Project	Steamboat Base Village Redevelopment	Date	07/23/2021
Project Location	Steamboat, Colorado	Architect's Project Number	03.7835.000
Owner/Client	Alterra Mountain Company / East West Partners	File	6BL This is page 1 of 2
To	Saunders Construction Inc.	Attention	Bryan Sculthorpe
Address	86 Inverness Place North		
City	Englewood	State	CO Zip Code 80112
Delivered via:	<input type="checkbox"/> Messenger <input type="checkbox"/> Hand carried <input type="checkbox"/> Facsimile <input type="checkbox"/> Express <input type="checkbox"/> Pick-up <input type="checkbox"/> E-mail Address <input type="checkbox"/> Mail <input type="checkbox"/> UPS <input checked="" type="checkbox"/> Website Address BIM360

Bulletin Number - BP3 Promenade - 06

Description of Changes

This bulletin addresses the following:
Landscape planters, site walls, associated grading
Telecom sheet updates for on mountain coordination

COMPOSITE SECTIONS
1A-L7-08

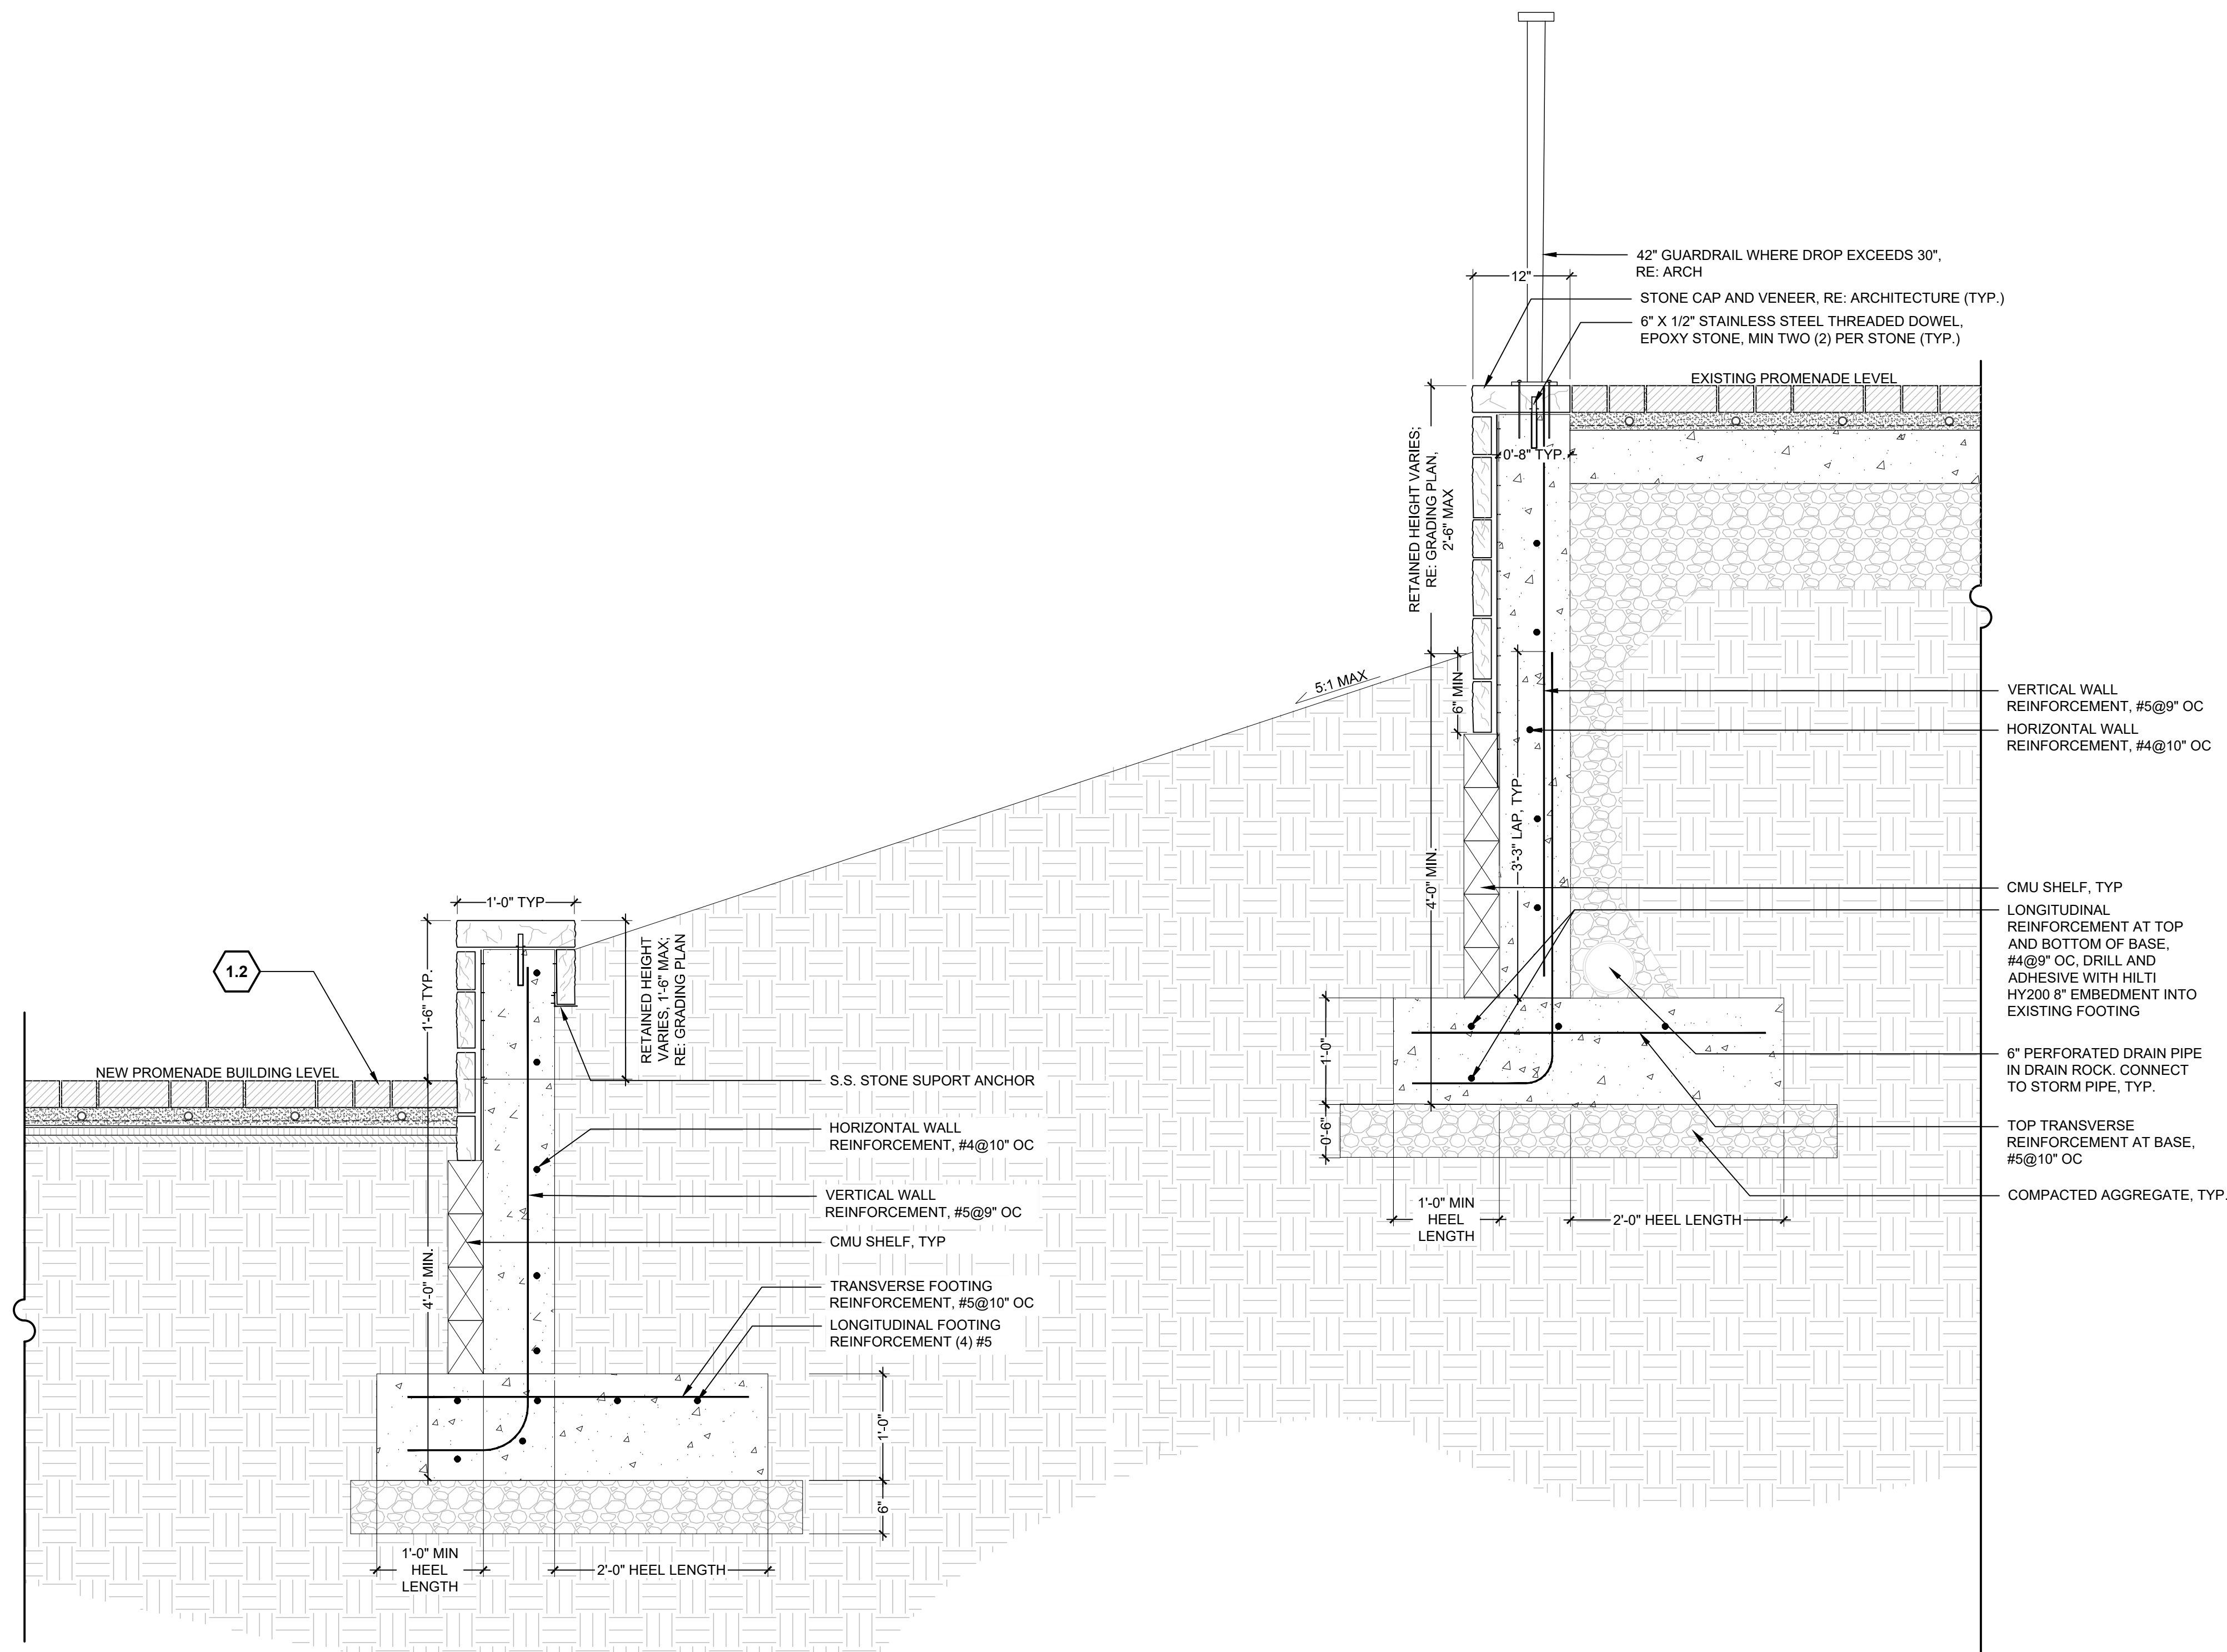
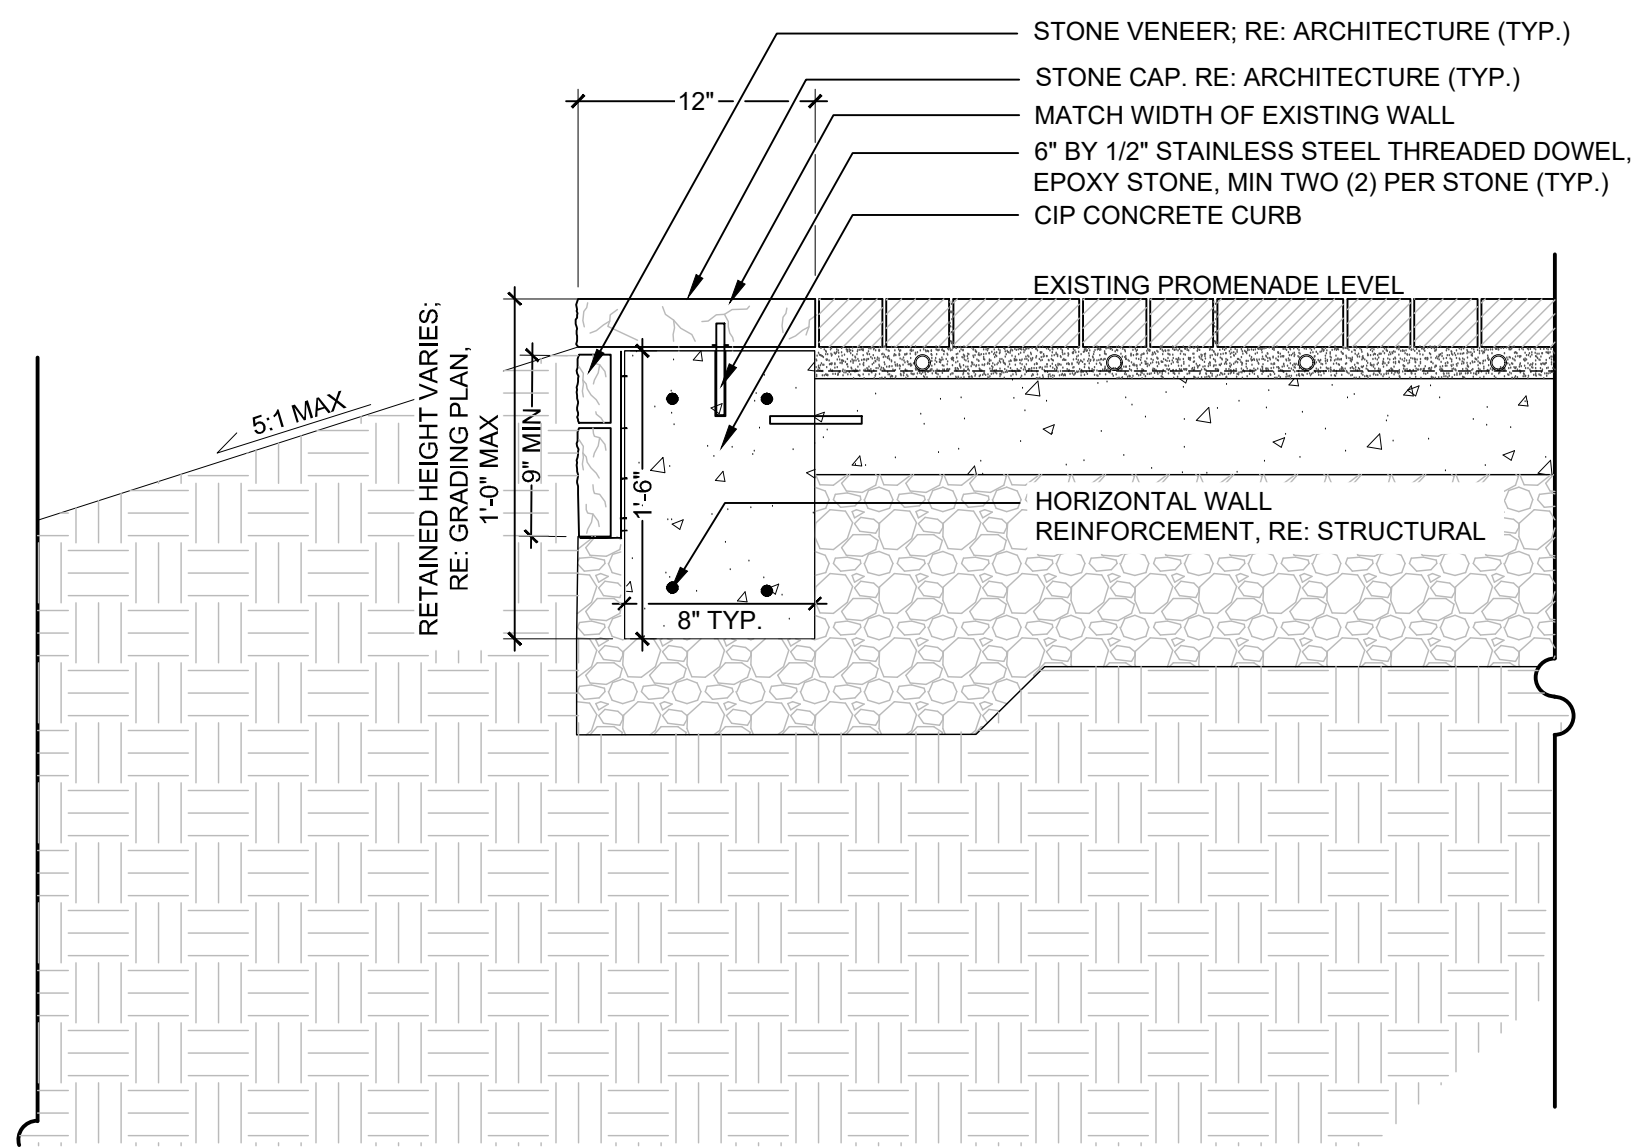
1A-L7-02 Site Details	Section 2 revised to include wall type 5.
1A-L7-03 Site Details	Sections 2 and 3 revised/added to show wall details type 3 and 4.
1A-L7-04 Site Details	Section/Elevation 1 title change to wall type 2.
1A-L7-08 Composite Sections	Elevation 2 added and elevation 3 revised to show relationship of southern promenade walls and transformer.
1A-L7-11 Site Details	New sheet showing wall types 5 and 6.
1A-L8-01 Planting Plan	Eastern tree removed from northeastern planter, shrubs and groundcovers reduced to accommodate new planter size.
1A-L8-02 Planting Plan	Trees, shrubs and added to fill larger planter at lower promenade level.
Irrigation Sheets:	
1A-IR-01 Irrigation Plan	Adjusted irrigation to match new planter geometries.
